Oil Seepage at Flywheel Housing

SB-10044248-9001

FSB 212-002, Oil Seepage at Flywheel Housing

(April 2012)

W4070253

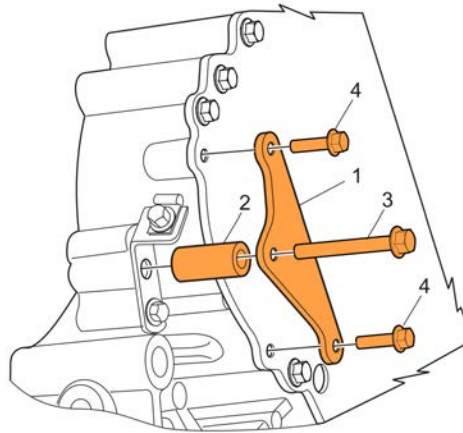
14 Install the stiffening bracket, using the correct fasteners and spacers and torque to specifications.

Note: 3 possible installations, please refer to illustration for installation and part numbers.

Note: To be used on vehicles with AHI bracket.

Item Number	Description	Part Number
1	Bracket	21604236
2	Spacer	21604234
3	Flange Screw	975103
4	Flange Screw	946470

W4070538

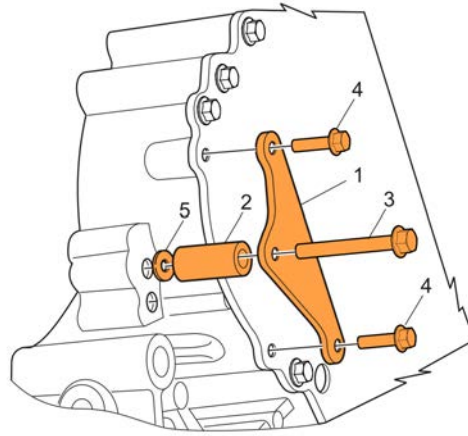
Note: To be used on vehicles without AHI bracket.

Item Number	Description	Part Number
1	Bracket	21604236
2	Spacer	21604234
3	Flange Screw	975103
4	Flange Screw	946470
5	Washer	941744

W4070537

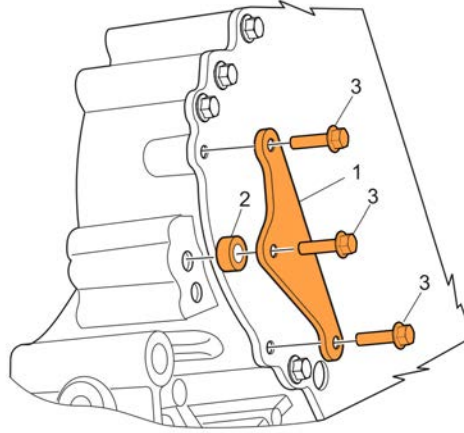
Note: To be used on vehicles with mounting hole almost flush with top of flywheel housing.

Item Number	Description	Part Number
1	Bracket	21604236
2	Spacer	21604234
3	Flange Screw	975103

Note: M8 24 ± 4 Nm (18 ± 3 ft-lb)
M10 48 ± 8 Nm (35 ± 6 ft-lb)
